PL-09-00778 505 Woodside Avenue – Appeal of Design Review

Historic Preservation Board Staff Report

Subject: 505 Woodside Avenue
Author: Brooks T. Robinson,
Principal Planner
Project #: PL-09-00778
Date: February 3, 2010
Type of Item: Quasi-Judicial Appeal

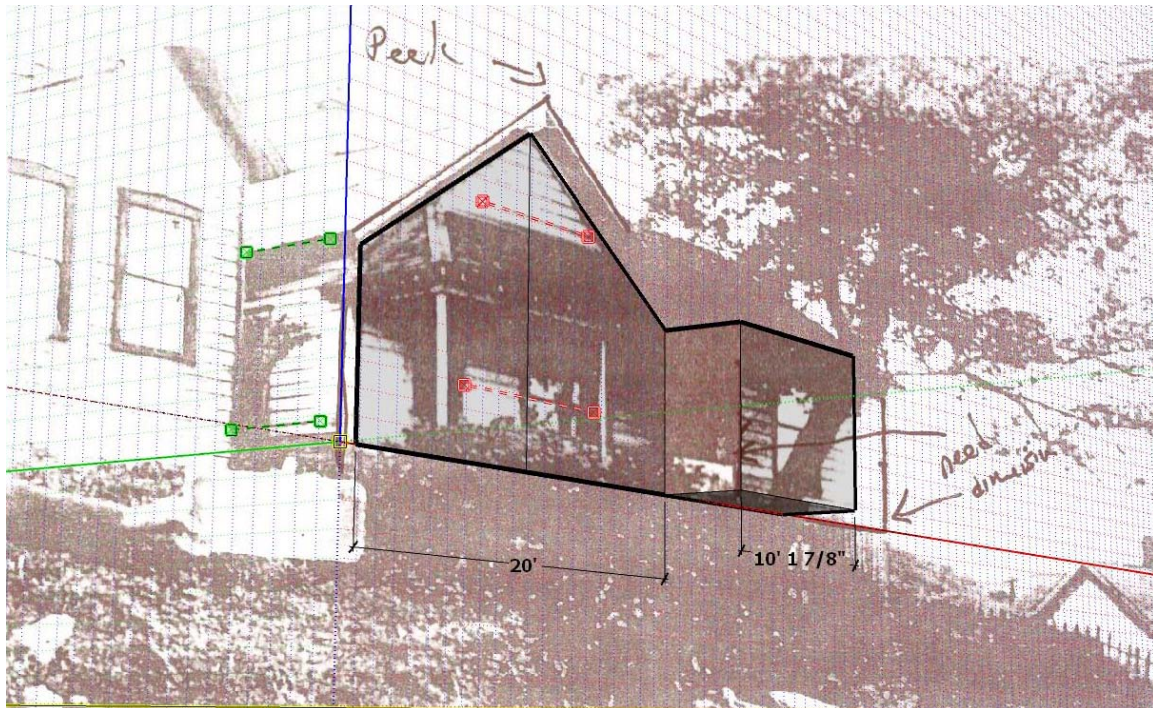
The applicant based the current design on the re-creation of the 1940's photo and the tax records. A certificate of appropriateness for demolition is not required because the home is being preserved back to the 1940's design removing non-contributory additions. The removal of non-contributory additions may be approved at a staff level during the historic district design review process. The architect estimated the width of the north side of the front façade to be 10' 6" wide.

Due to the appeal, the applicant hired a design consultant to measure the width of façade based on the 1940's photo and existing dimensions. The consultant utilized sketch-up software to reproduce the photo of the historic building and identify the exact dimensions. The width of the area in question was found to be 10' 1 7/8" wide. The following is the sketch-up exhibit produced by the applicant.

WEST ELEVATION

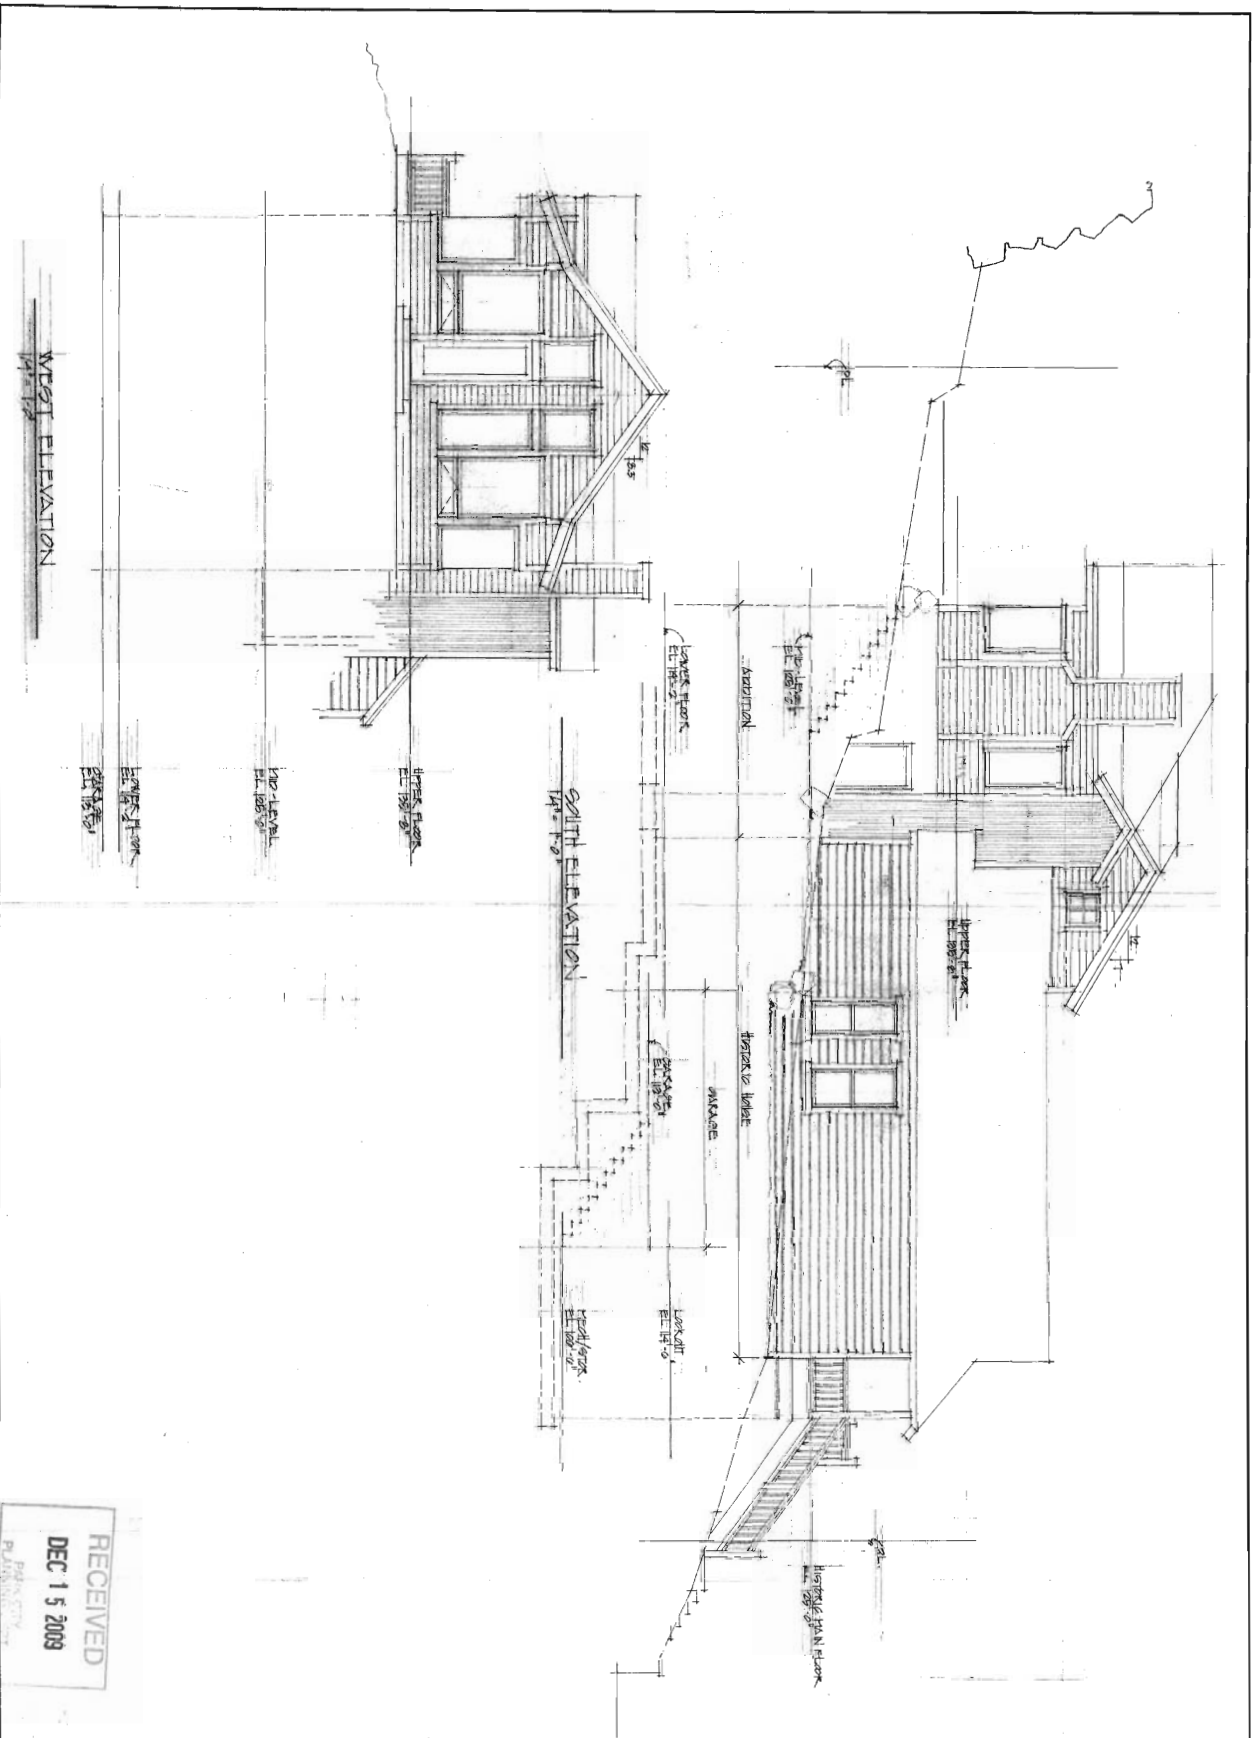
- There is no roof elevations represented anywhere let alone on the Site plan according to the submittal requirements / application sheet.
- The existing grade elevation line is inaccurately represented on the North Elevation

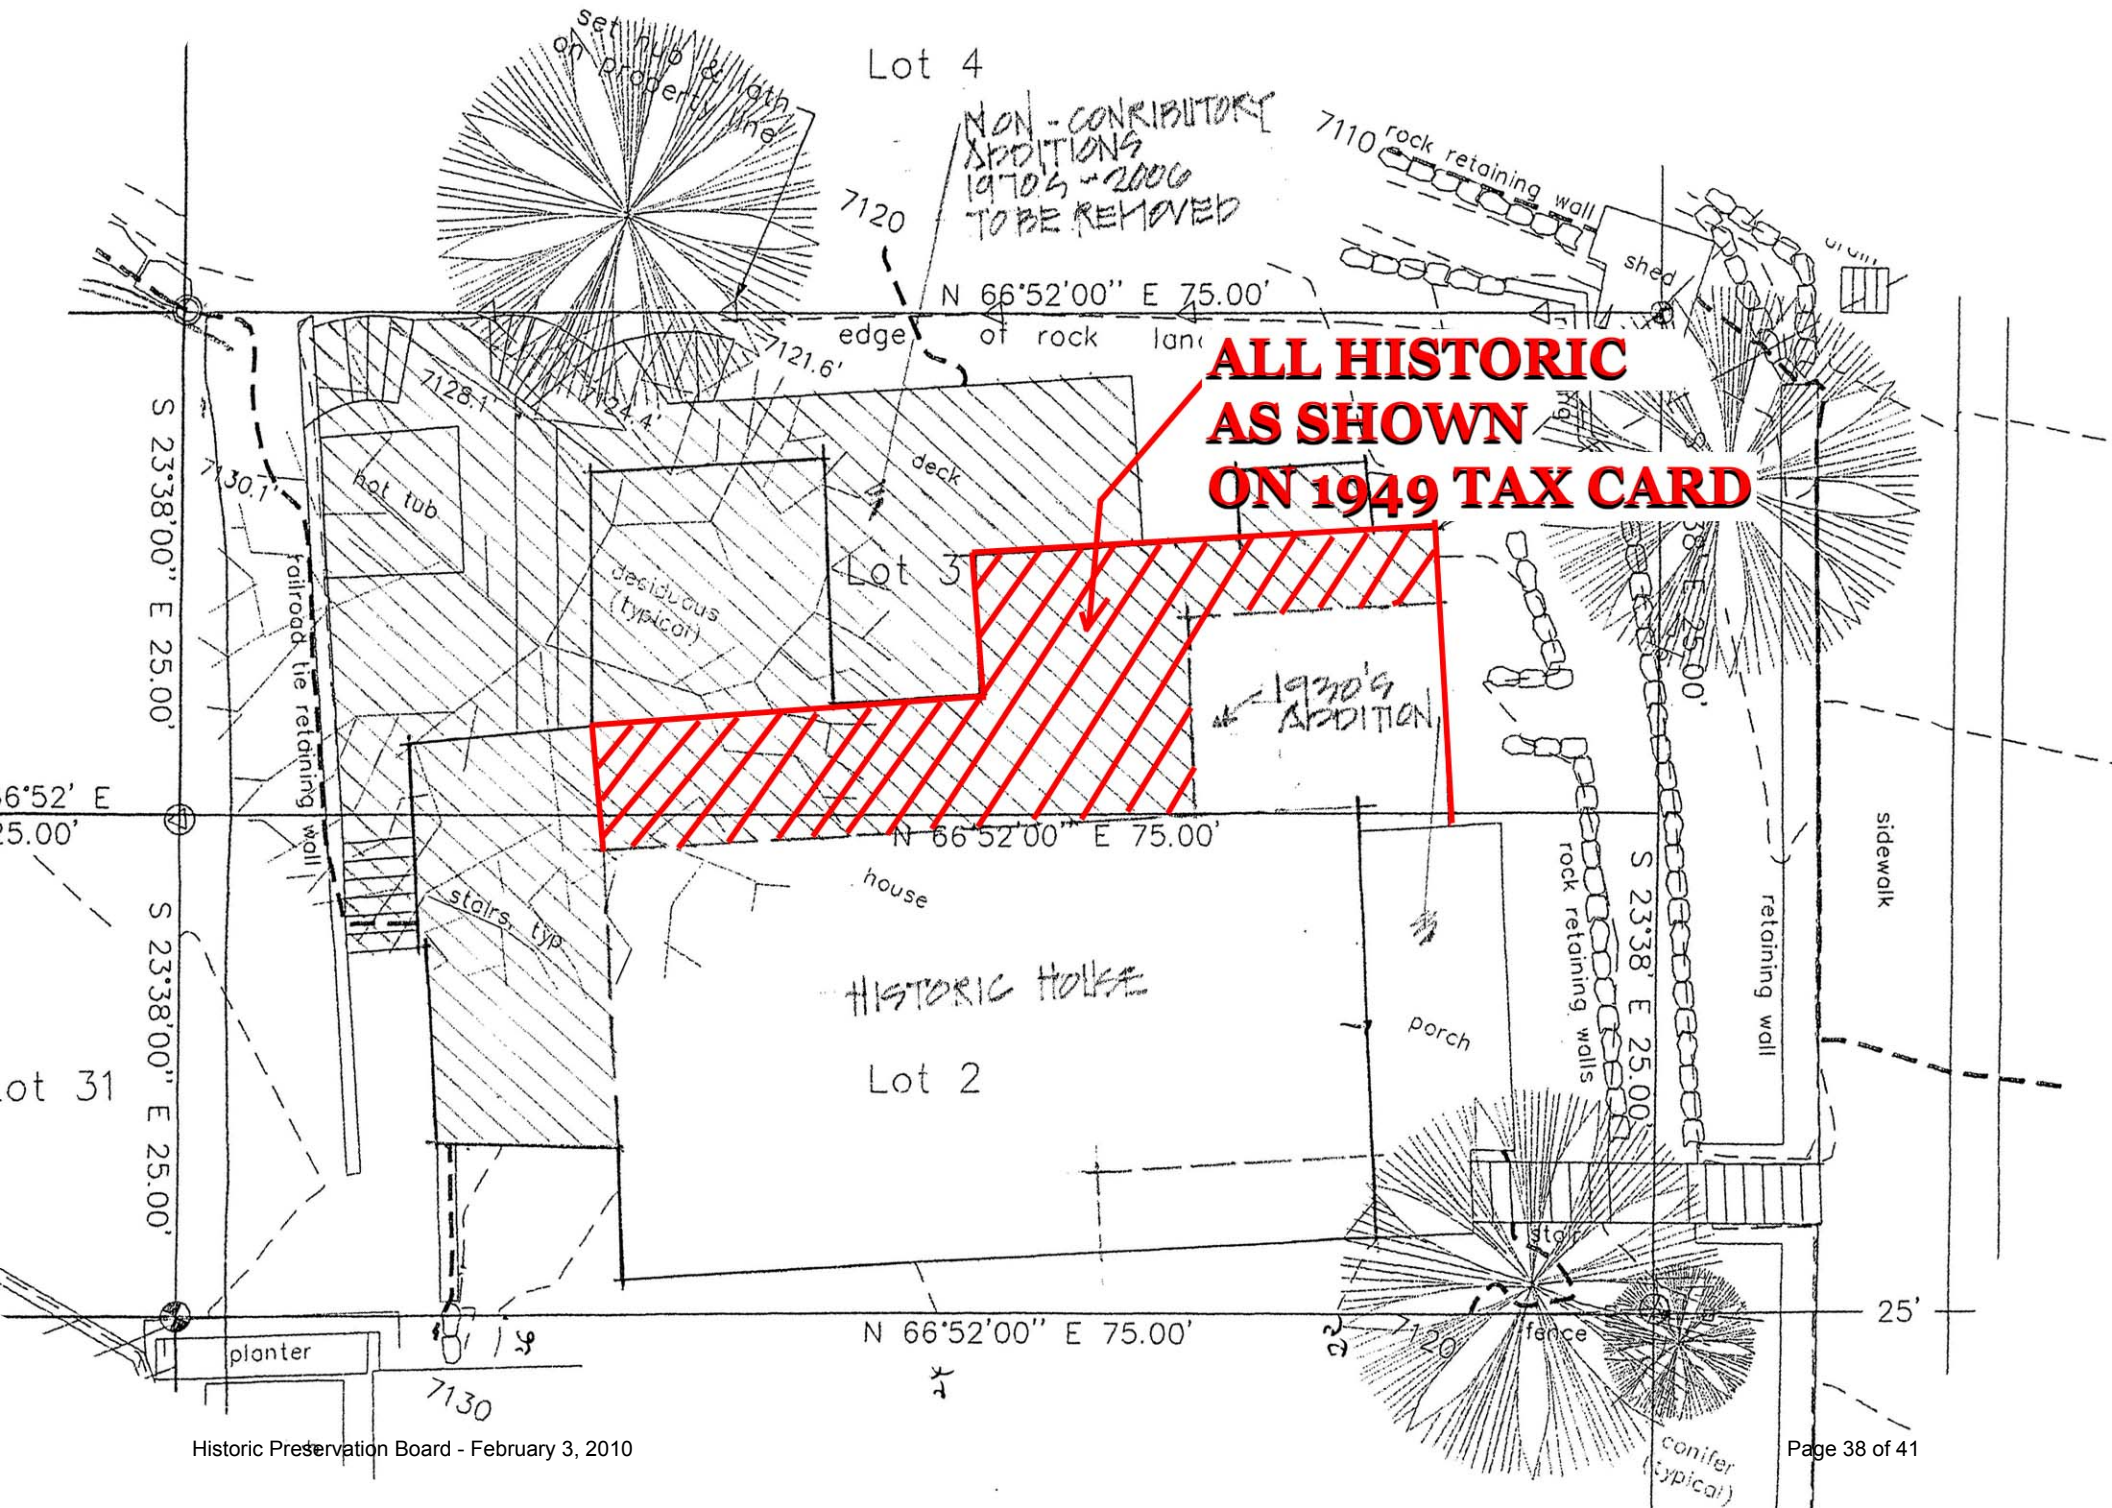
HISTORIC NORTH GABLE END
23 FT. AS EXISTING ON BOTH THE CURRENT SURVEY
AND 1949 TAX SURVEY (SEE INVENTORY REPORT)
NOTE ALL ORIGINAL SIDING INCLUDING THIN EAVE
SAME AS OR BETTER THAN OTHER PARTS BEING PRESERVED

**ALL HISTORIC
AS SHOWN
ON 1949 TAX CARD**
